Re: Response to Pleasant Prairie Solar Township Board of Trustees public meeting

We are responding to Prairie Township's request for comments following the township's meeting of May 25 on the proposed Pleasant Prairie Solar facility, part of which would be in Prairie Township (<https://www.prairietownship.org/426/Pleasant-Prairie-Solar-Energy-Project>).

To: Josh Hreha, Project manager, Invenergy
From: Darby Creek Association and Columbus Audubon
Subject: Communication regarding proposed Pleasant Prairie Solar Project
Date: January 26, 2021

Case No(s). 20-1679-EL-BGN

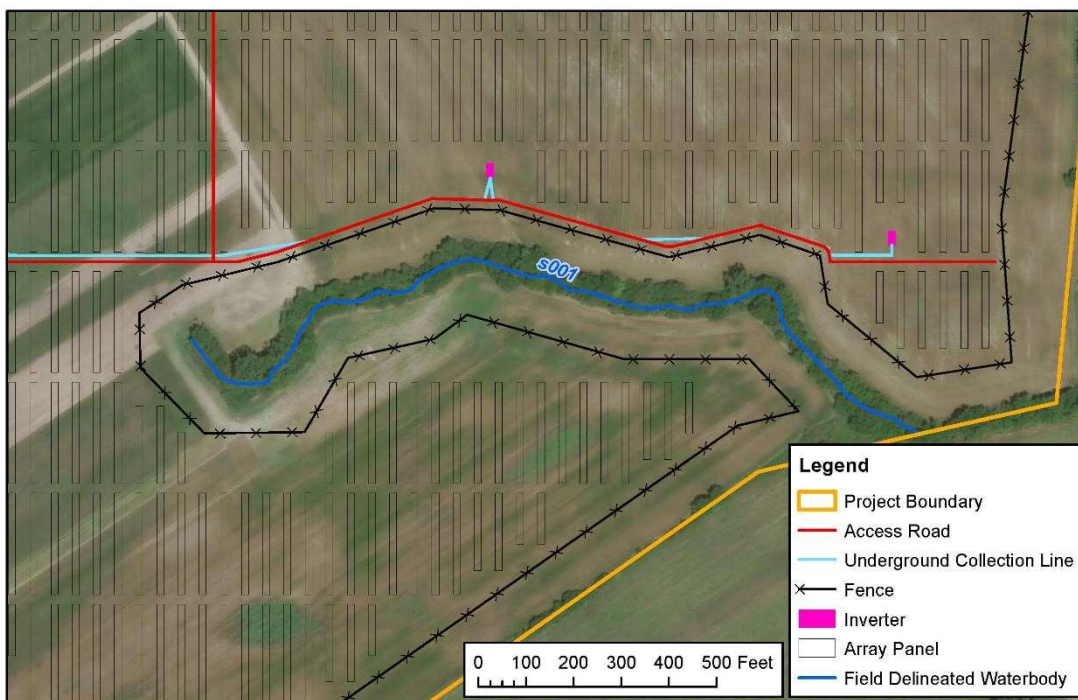
- 1) Wetlands: The facility should ensure adequate protection of wetlands, starting with a complete and proper Inventory and delineation of all wetlands, including temporary wetlands (Category I), and adequately protective buffers, adequate protection of wetland hydrology, preservation and enhancement of wetland wildlife, and connection to conservation land. We understand that as part of Clean Water Act obligations the facility will need to produce wetland identification, delineations and wetland scoring for the Army Corps of Engineers and Ohio EPA. We expect to have other protection points to follow. We expect that wetland impacts will be avoided to the greatest extent practicable, and that significant wetland enhancement might be possible, especially given the proximity to Battelle-Darby Metro Park.

As part of our site evaluation, the Project team conducted a detailed survey of surface waters (wetland and waterbody delineations) within the Project Area in fall of 2020. This Report was provided as part of our Application to OPSB, see Exhibit C - part 5 of 25.

This report provides details on delineated features including their scoring on the ORAM or HHEI/QHEI assessment forms. A total of 15 wetlands and one pond were delineated during field surveys, for a total of 8.15 acres of wetlands within the Project Area. Eleven of these wetlands were categorized as emergent, three were categorized as forested, and one was categorized as shrub-scrub. One wetland (W-002) was categorized as potentially jurisdictional and scored as lower quality wetlands on the ORAM. No wetland crossings are proposed, and we anticipate no impacts to wetlands from the construction or operation of the Project based on our current design.

The Project has also developed a Landscape and Vegetation Management Plan (Exhibit E to the Certificate Application), that provides details on stabilization, and the planting of native, low-growing, herbaceous vegetation. This land cover will provide a greater diversity of species and will be maintained year-round, as opposed to seasonal disturbance of crop harvest, providing continuous ground covering and stabilization. This maintained ground cover will reduce runoff and sedimentation to local waterbodies in comparison to an agricultural field. As well as act as a vegetated buffer around the existing wetlands.
